Government of West Bengal
Irrigation & Waterways Department
Jalasampad Bhavan, 3rd Floor, Western Block
Bidhannagar, Salt Lake City, Kolkata 700 091

Memo No. 36/8- IFC
IW/0/IFC-4M-30/2014

Sub: Making provision of use of brick block pitching/interlocked brick block pitching/dry brick pitching instead of Concrete block pitching/brick block pitching/dry brick pitching for protection of the severely eroding Sundarban Embankments as embodied in the Departmental "Guidelines on Riverbank Protection & Anti sea erosion works in West Bengal (2nd Revision)" under para 6.5.1 & 6.5.2

Sub.: Modifications of River protection manual of I&WD related to protection of banks and Embankments in Sunderban.

Fig. 33: Bank Protection Type-E1 (For zone E)

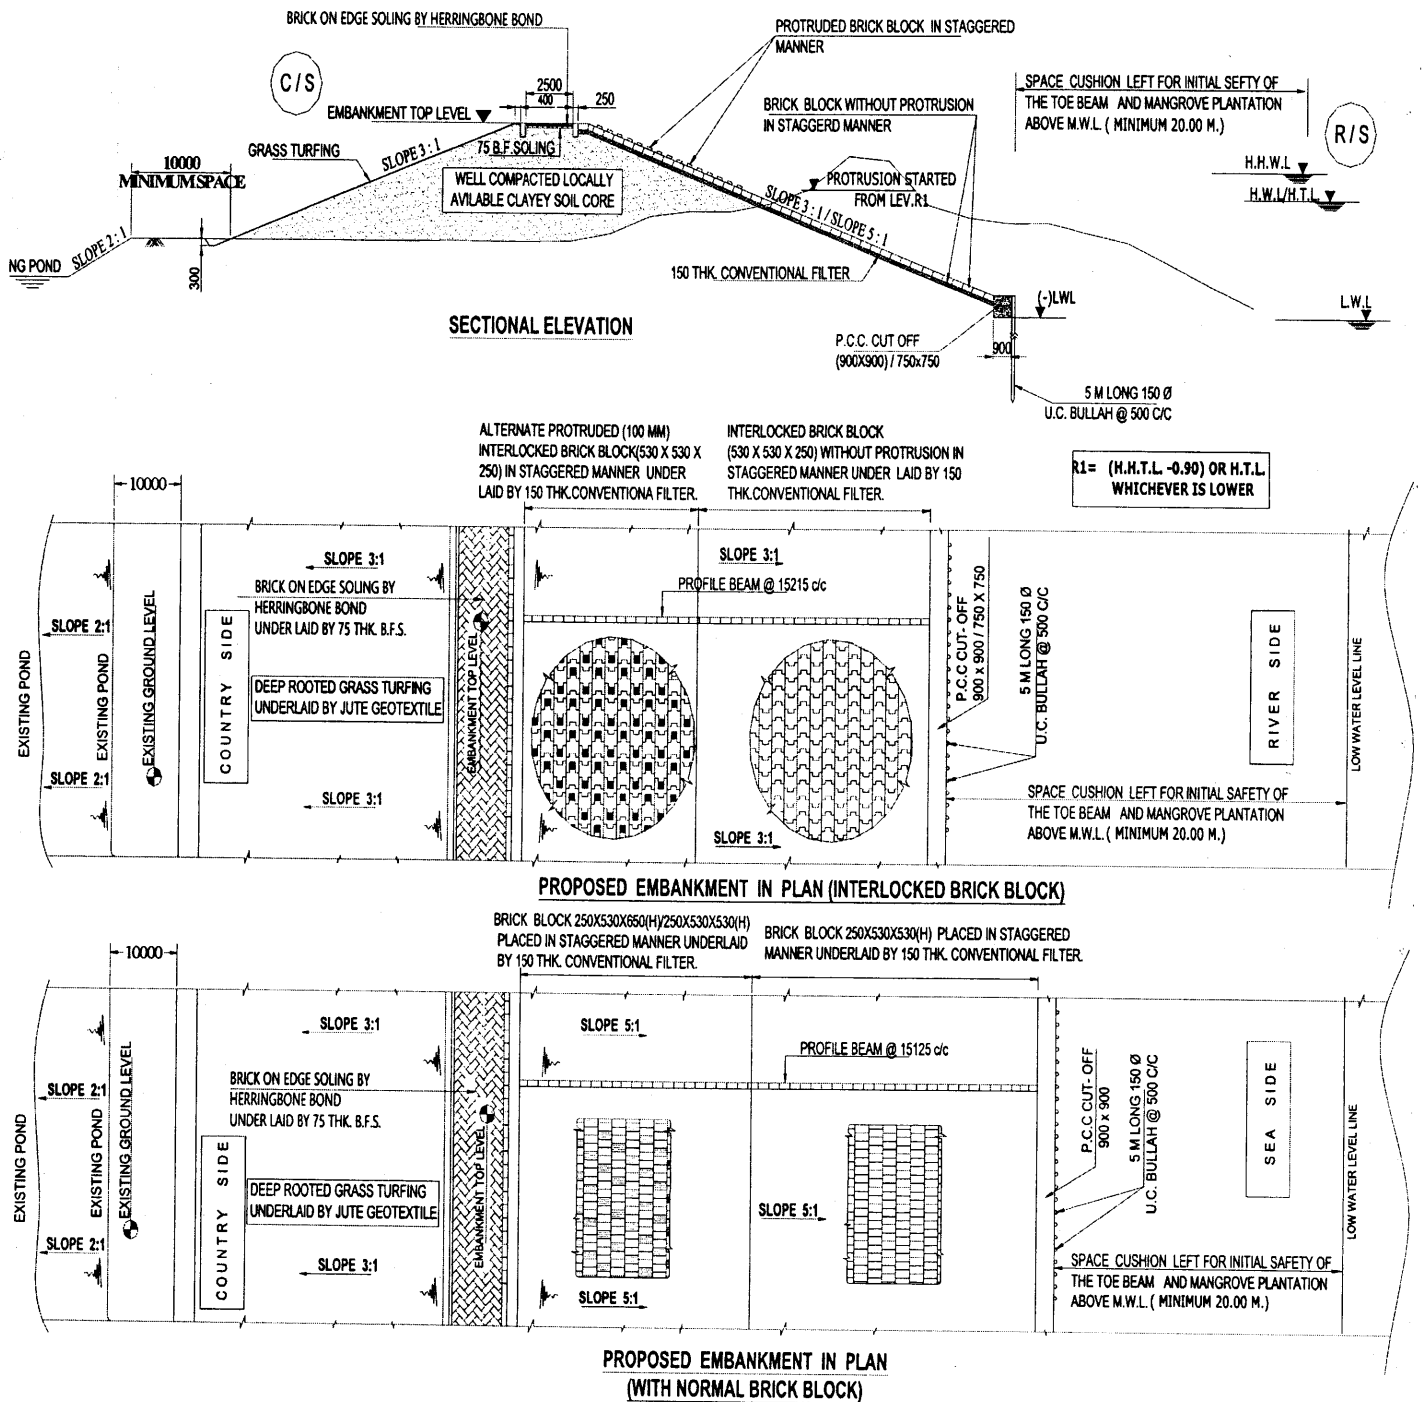
Description: Brick block pitching (530mm thick) / interlocked brick block pitching (250 thick) / dry brick pitching on river or seaside slope over conventional filter with toe walls as per Fig. 33 with dimensions as per Table 11.0.

Fig. 34: Normal and interlocking Brick Block (For zone E)

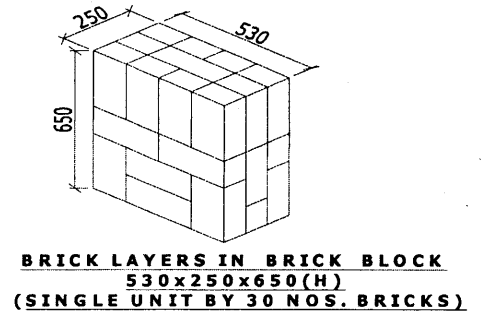
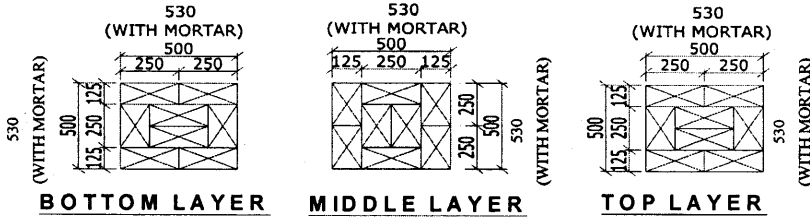
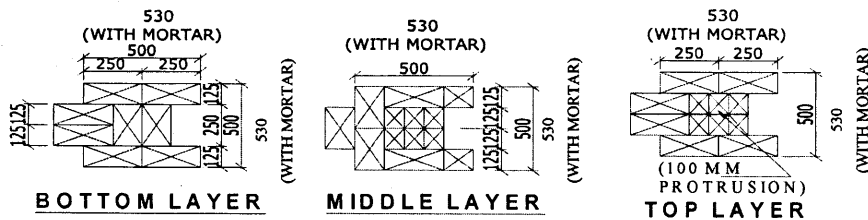
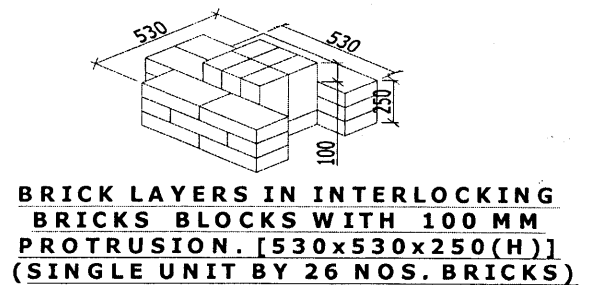
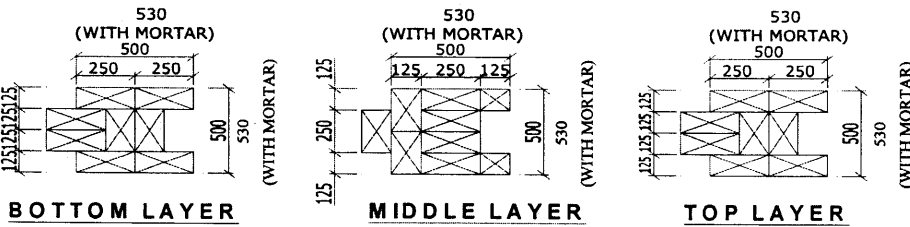
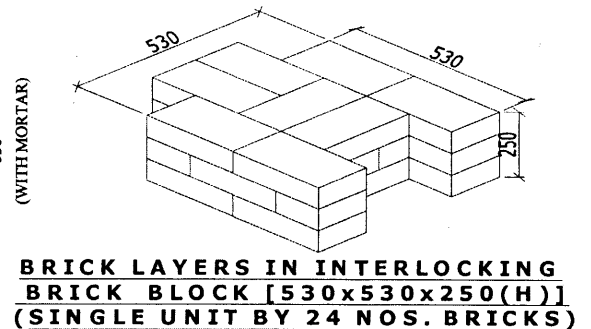
Note: A. Interlocking / normal brick block may be provided on slope for Sundarban regions. Shape as decided and shown. Bricks shall be of 1st class kiln burnt bricks having crushing strength not less than 10.5Mpa, should absorb water greater than 20% of its dry weight when immersed in water for 24 hrs, metallic sound come out when stuck together, shall develop no impression when scratched with fingernails. They must be prepared having cement: sand mortar in proportion of cement: sand 1:4.

Fig. 35: Foreshore protections with curved T Spurs and Mangroves (For zone E)

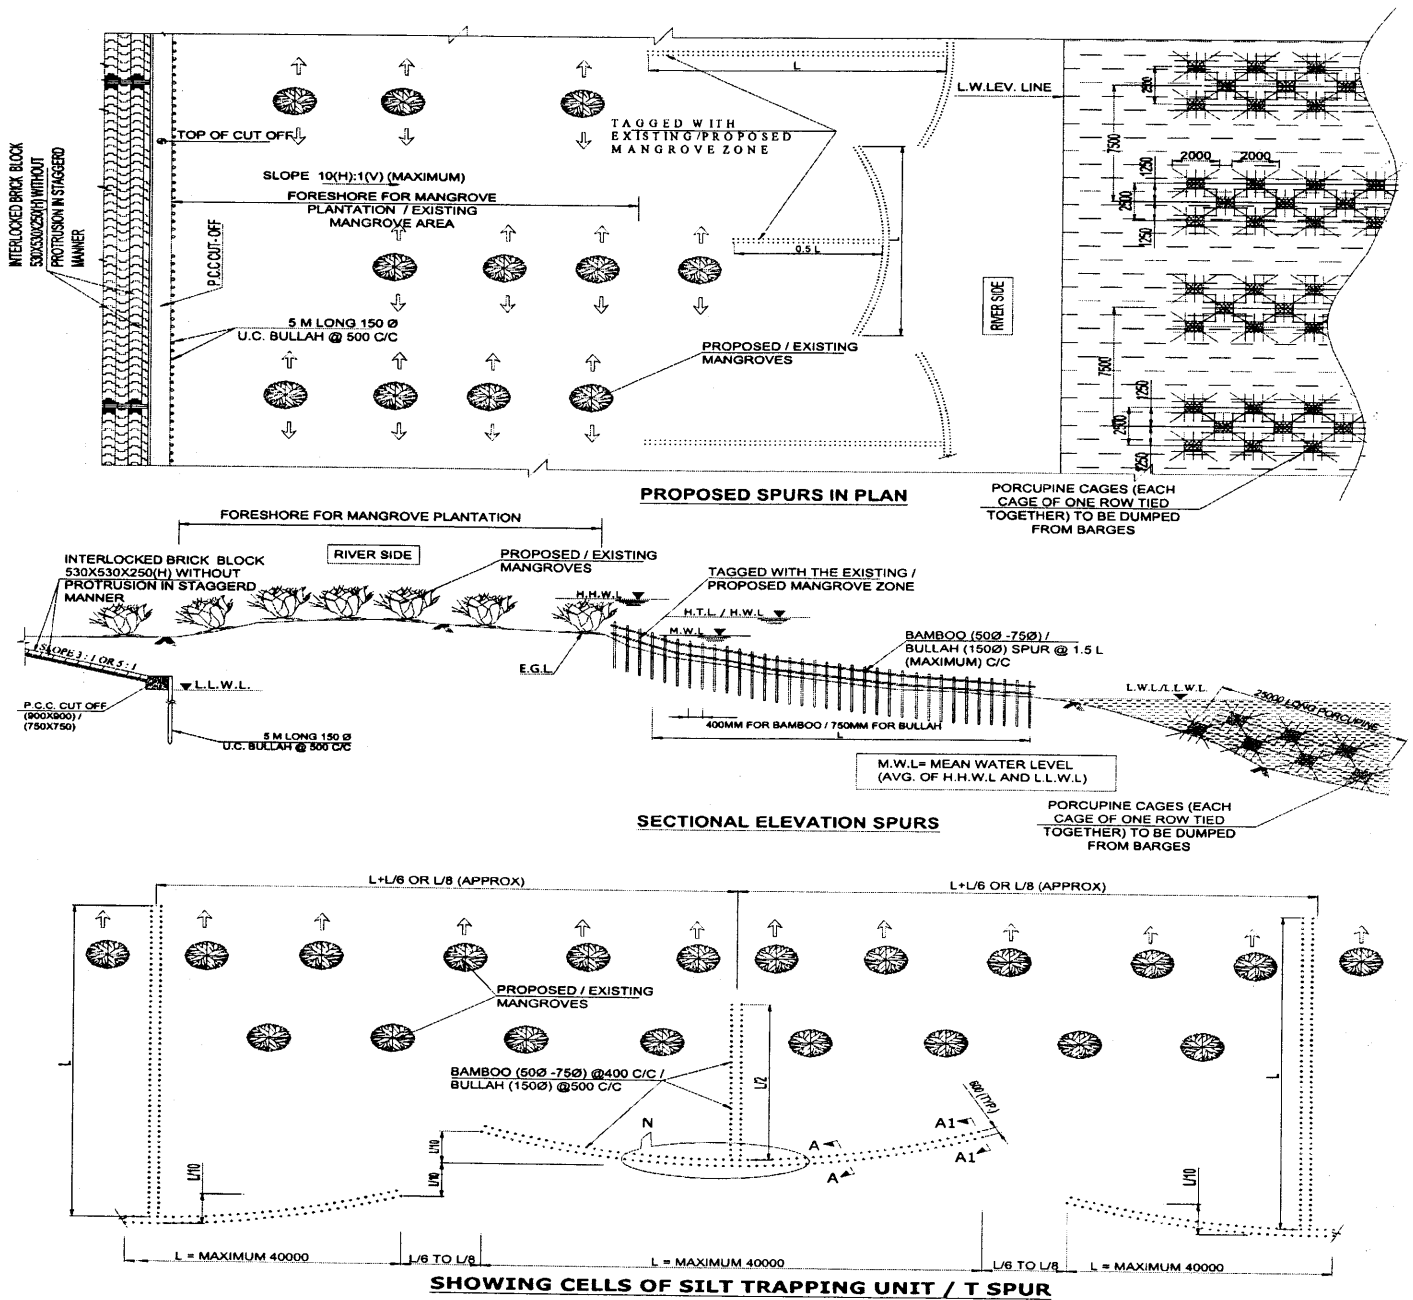
Description: A foreshore is the section in front of embankment and can be horizontal or up to a maximum slope of 1(V):10(H) and having a minimum length of one wavelength. Where foreshore berm length is less than the wave length under storm (50metres) porcupine cages may be dumped as per site suitability (except for the work under serial no 4 of the table 11.0, where porcupines are not required). Mangrove (*Avizinia*, *rizophora*) plantation along with suitable protection of propagules above the MWL i.e. mean water level (average of HTL and LTL) shall be carried out in staggered manner while the permeable spurs are to be made in the soil level below the mean water level and may be extended up to the LWL as per site condition. Below LWL porcupine may be dumped if required. Details survey is required for each of this case. Spacing and length of the spurs depend upon the vulnerability of the foreshore and may be consulted with CDO if required. Generally spacing is equal to 1.5xL is recommended where; L is the length of permeable spurs. Permeable T spurs shall be made with two layers of bamboo or bullah pins (generally 2/3 embedded

Fig. 36: Foreshore protections with silt trapping unit (For zone E)

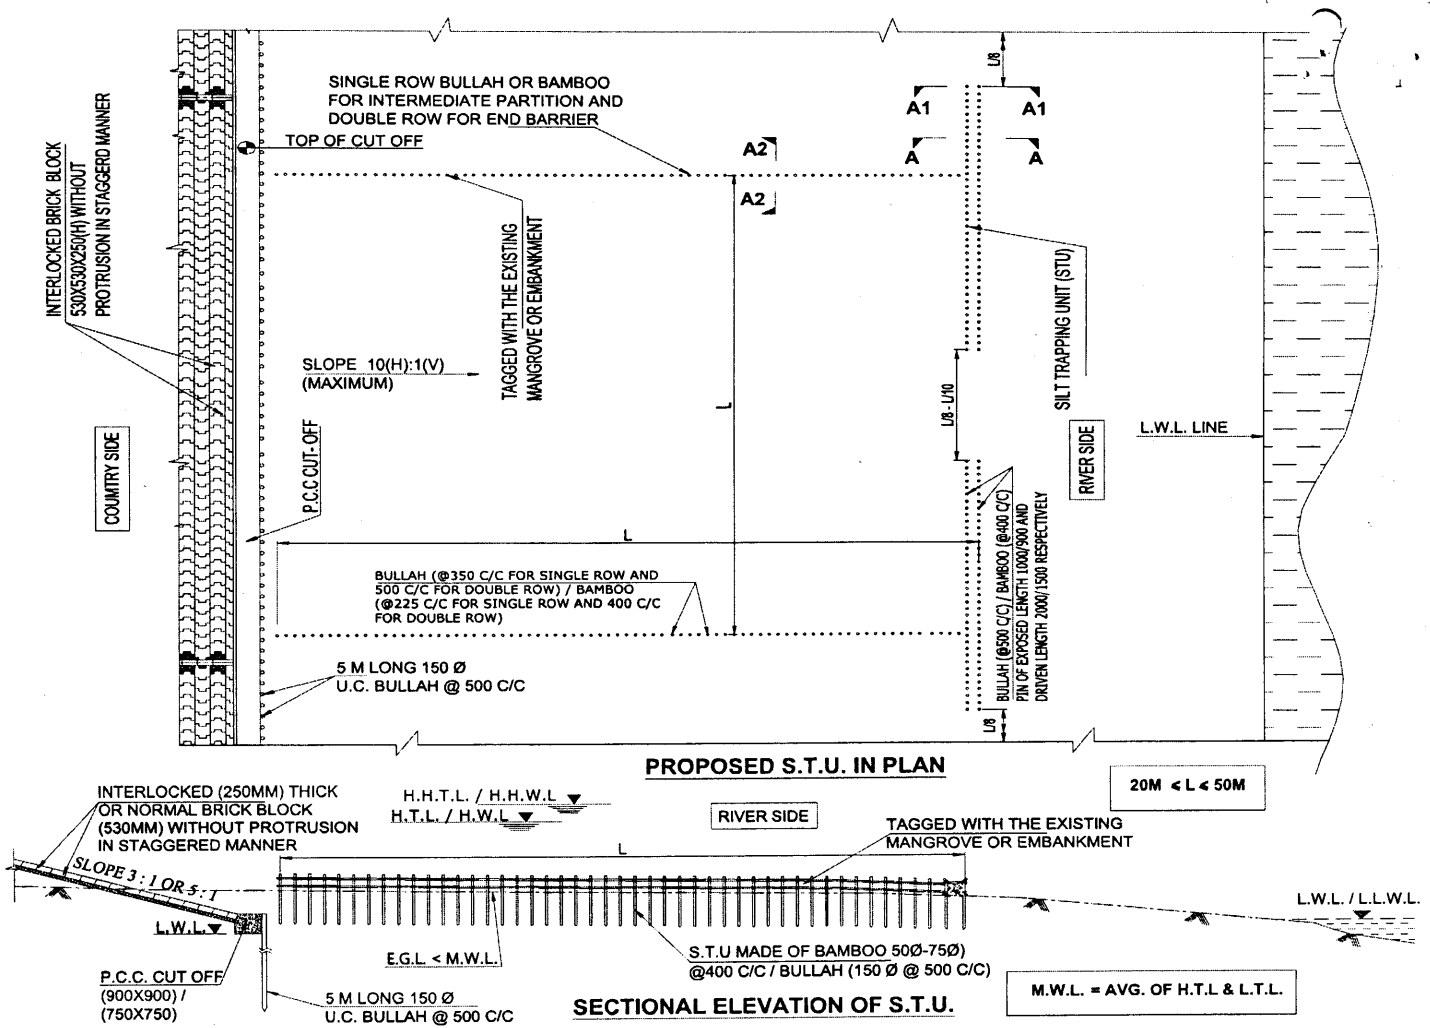
erosion has been observed for last few years, silt trapping unit using bamboo or bullah (where wave thrust is high, say in sea dyke bullah shall be considered and where wave thrust is less, say in river dyke bamboo shall be considered) need to be made as shown in the following fig 36.

and 1/3 length exposed) filled with locally available bush or locally available invasive species. If the foreshore berm level is less than MWL then double rows of bullah and bamboo may be driven at the foreshore as per Fig. 36 as a silt trapping unit. Terracotta rings can also be used as silt trapping unit as shown. The bamboo spurs shall be used in the less vulnerable area i.e. for river foreshore whereas bullah spurs shall be used where wave attack is high i.e. near sea. Country side slope (3(H):1(V) slope) shall be protected by good grass cover under laid by jute geotextile along with plantation of *Acacia nilotica* like trees.
